**Group of Experts for the revision of the IMO/ILO/UNECE
Guidelines for Packing of Cargo Transport Units**

Updates on the second draft of the Code of Practice for Packing of Cargo Transport Units

Comments on the second draft of the CTU Code

Transmitted by the expert of Slovakia

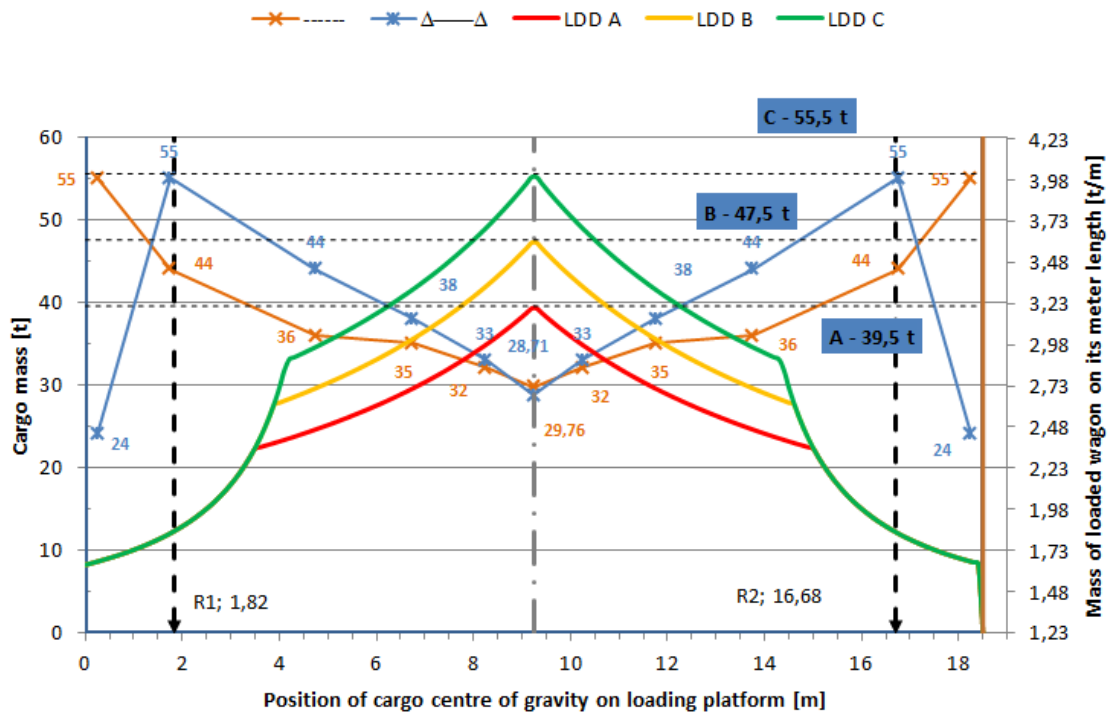
2. Sec. 6.3 – acceleration coefficient for combine transport. If permitted shunting speeds are not exceeded by rail operator than following acceleration coefficients for combine transport could be considered.

Rail transport (combined transport)				
Securing in	Acceleration coefficients			
	Longitudinally (c_x)		Transversely (c_y)	Minimum vertically down (c_z)
	forward	rearward		
Longitudinal direction	[0.5]*	[0.5]*	-	[1.0]*
Transverse direction	-	-	0.5	[1.0]*
*Above values apply for normal transport conditions. Under abnormal conditions, c_x may increase to 1.0 and c_z may decrease to 0.7]

Load distribution diagram of 40-foot maritime container loaded on two-axle Lgs container wagon and container chassis

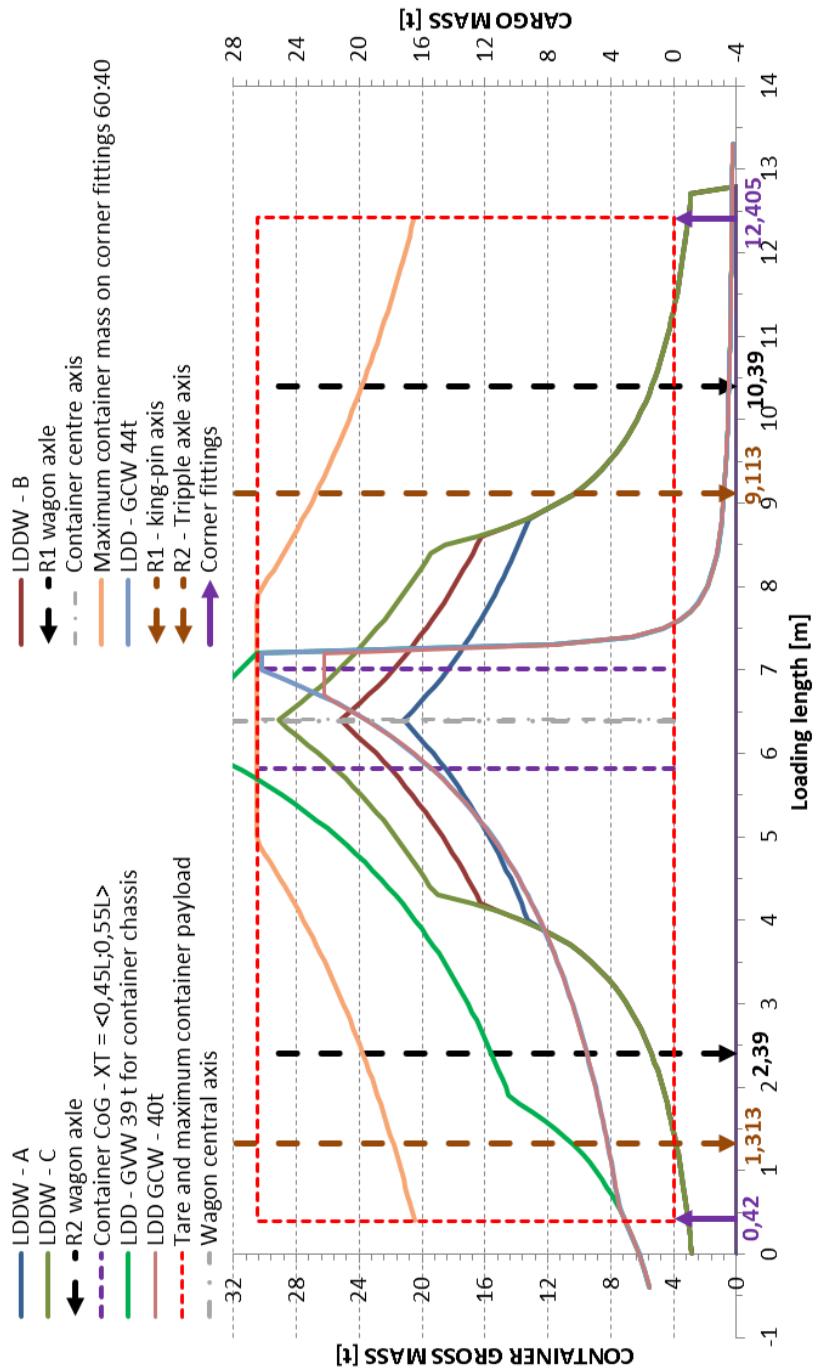
5. Sec. - 10.2.4.17 – Modular lashing systems can be used to such cargo mass which strength of the lashings points and number of lashing lines allows it. It can be used also to prevent upper incomplete layers against shifting.
6. Sec. – 10.3.1.4-to 10.3.1.7 – Examples of load distribution diagram of container and railway wagon shall be inserted. Also our previous comments refer to intermodal load distribution diagrams (for explanation see http://pernerscontacts.upce.cz/26_2012/Jagelcak.pdf). Equations (1) and (2) should be as follows>

$$R_{2max} = 0.5 \cdot (P + T) - 0.05 \cdot P \cdot \frac{L}{l} = 13911.03 \text{ kg}$$

$$R_{1max} = 0.5 \cdot (P + T) + 0.05 \cdot P \cdot \frac{L}{l} = 16568.97 \text{ kg}$$
